Planning and Zoning Commission

May 4, 2021

TO: Planning and Zoning Commission
FROM: Evann Martin, Assistant Planner
DATE: May 4, 2021
RE: Arby's - Site Plan

RE: Arby's Site Plan

Sheet 3:

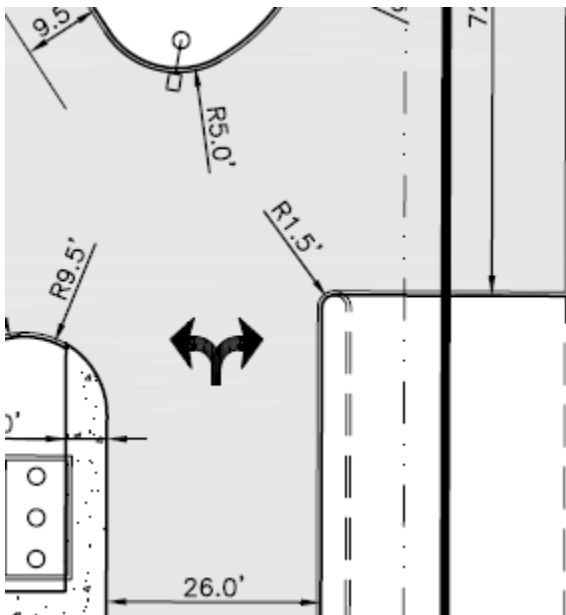
- ~~1. Update City notes. Attached are the latest notes from 3-12-21.~~
2. Label parking setbacks. 10' required from ROW and 5' from side property lines.
Revise north parking setback to 10'. 10' is now the base requirement so the label should be revised.
- ~~3. Drive thru lane needs to be 12' wide.~~
- ~~4. Angled parking depth is not measured correctly. Please revise. See diagram below.~~

- ~~5. Single drive lanes to be 16' wide.~~
- ~~6. Provide sidewalk connection from NE 2nd Ct to the building. Add domes to north ramp.~~
- ~~7. Provide a two-way through drive along the south of the site to connect to Lot 1 and 3. Two-way drives must be at least 24' wide.~~
- ~~8. 90-degree parking along the south would better accommodate the two-way traffic~~
- ~~9. Provide truck turning movements.~~
- ~~10. Label stop sign locations.~~
- ~~11. Please provide rolled curb where the striped islands are shown on the plans.~~
- ~~12. Under General Note 5, change construction division to Engineering Dept.~~
- ~~13. Under Pavement Thickness add ROW to be 8" PCC.~~
- ~~14. Please revise radius to 10' on island along the drive-thru lane.~~

11 TRASH ENCLOSURE DETAIL
FOR INFORMATIONAL PURPOSES ONLY (REFER TO ARCHITECTURAL PLANS FOR CONSTRUCTION DETAILS)

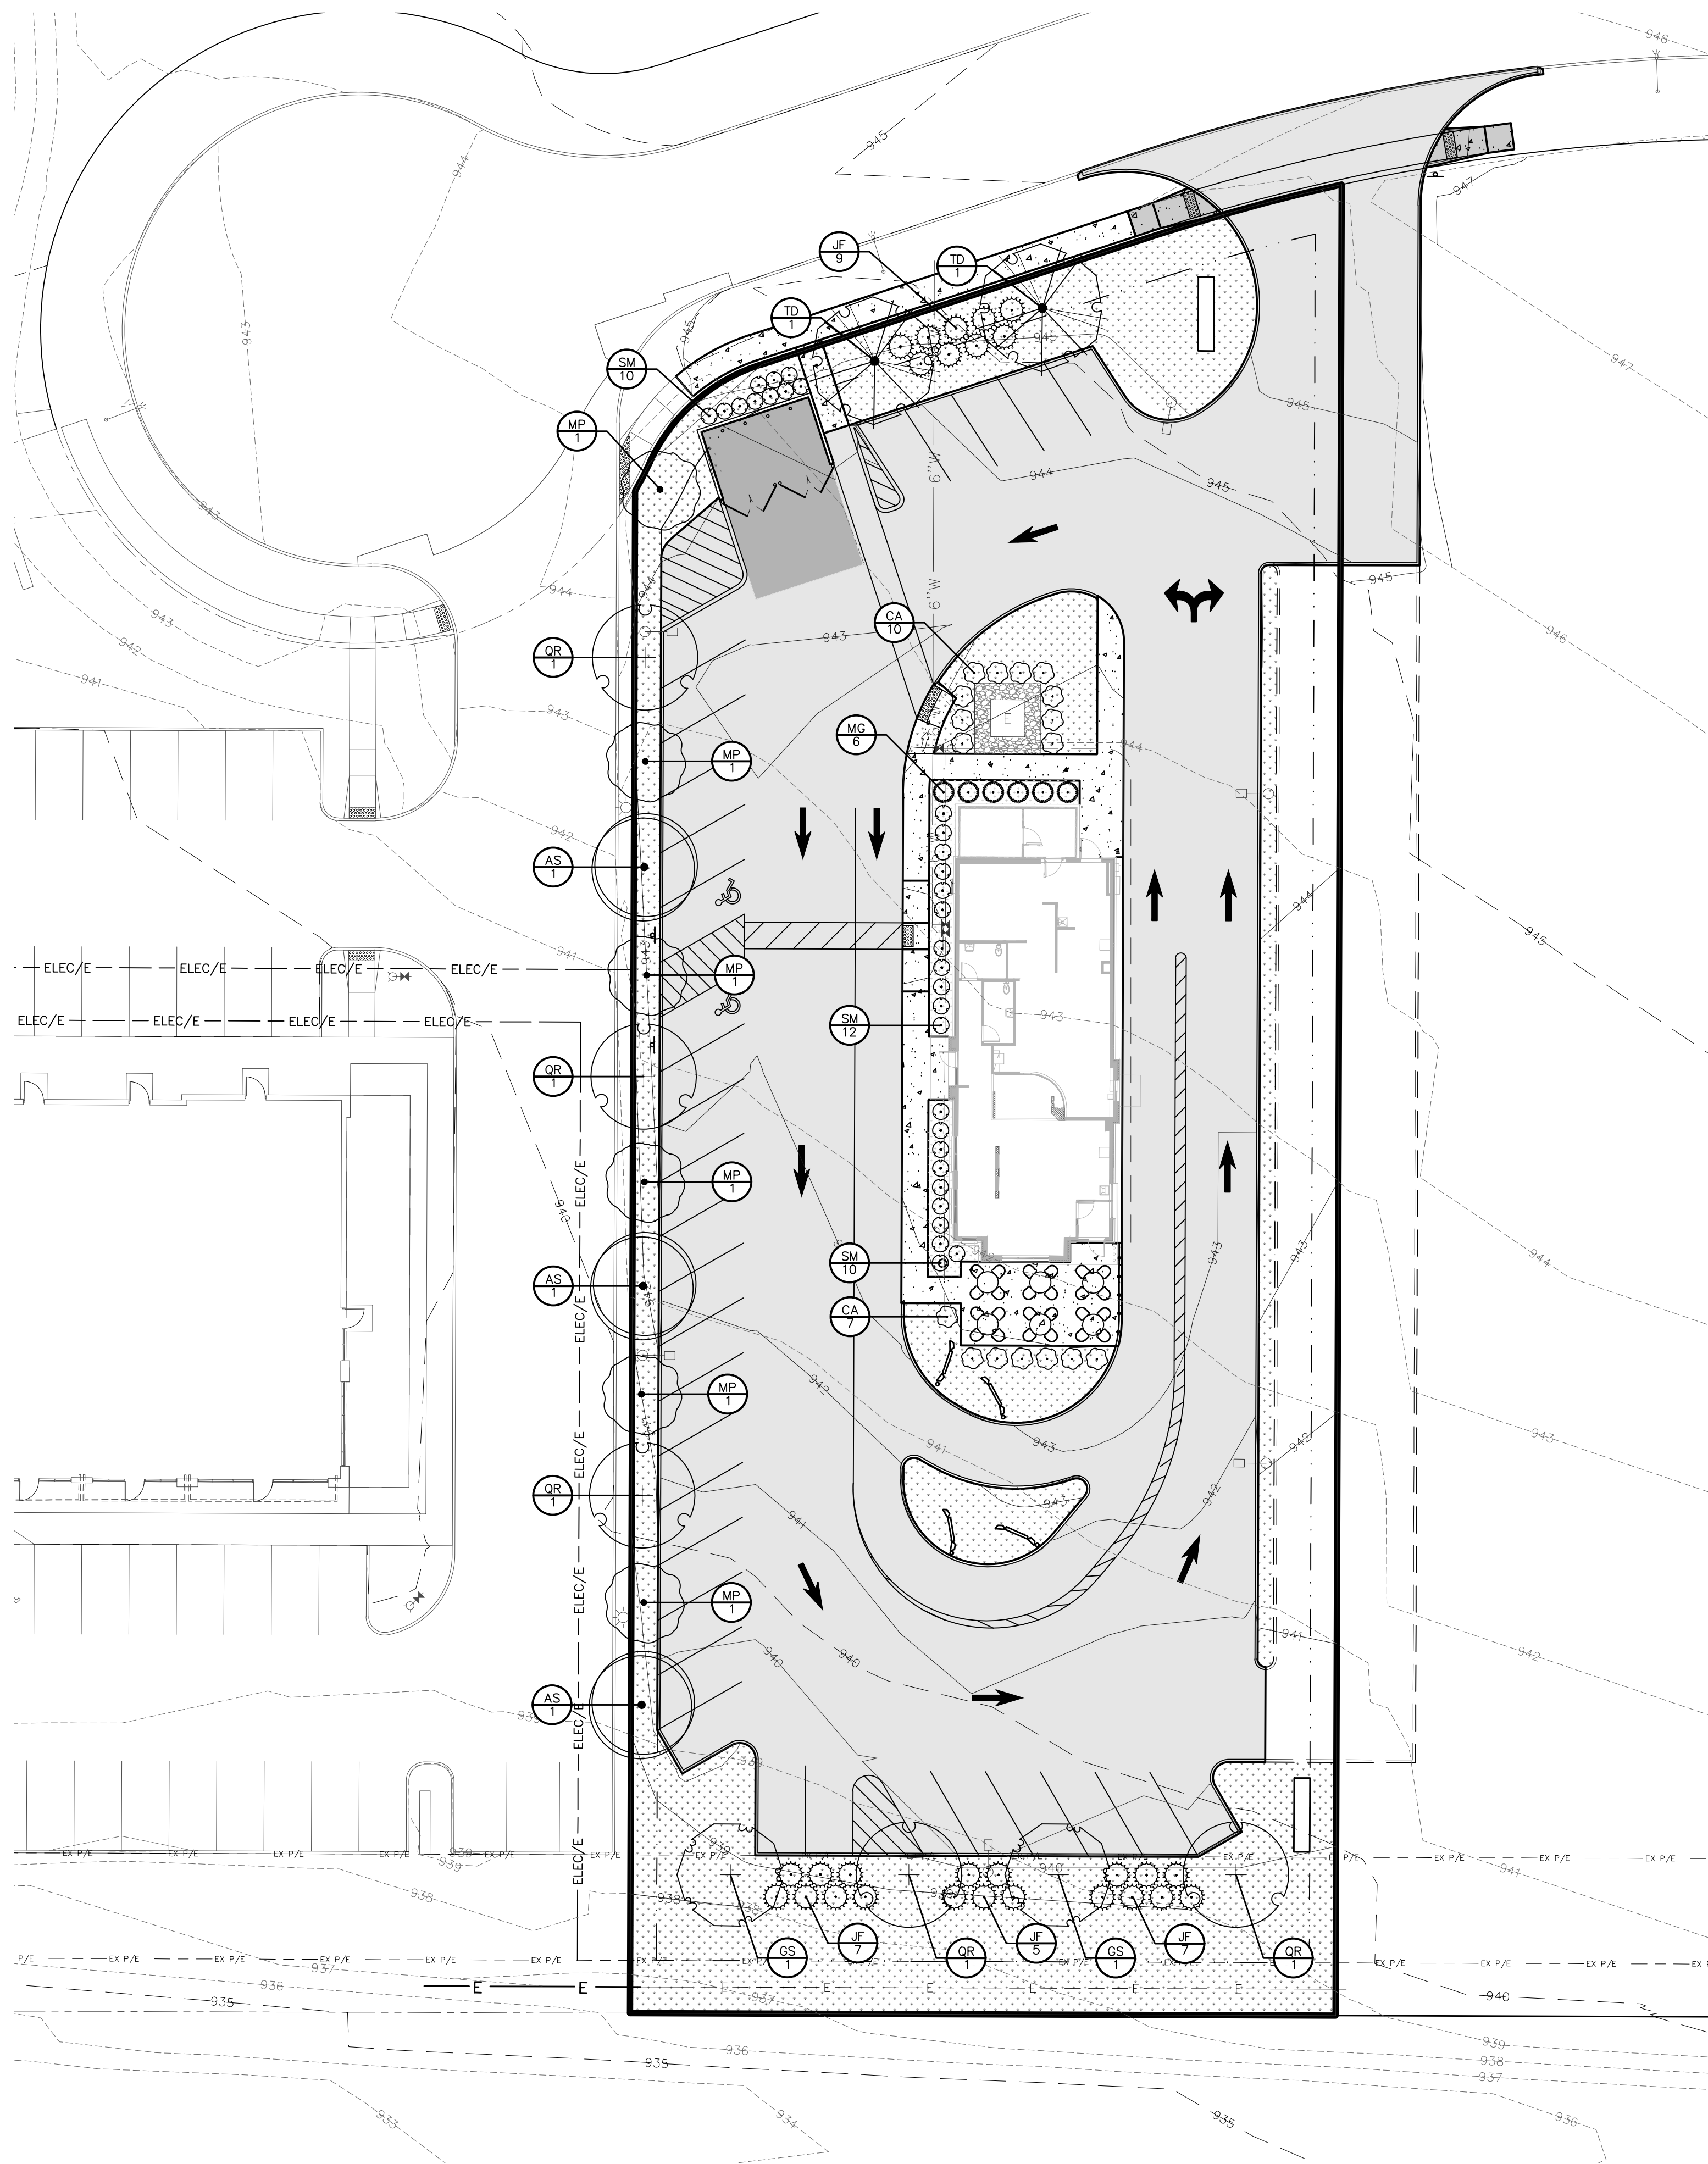
1. The dumpster gates cannot be chain link with slats. It must be a framed opaque gate. Please revise the gate material.
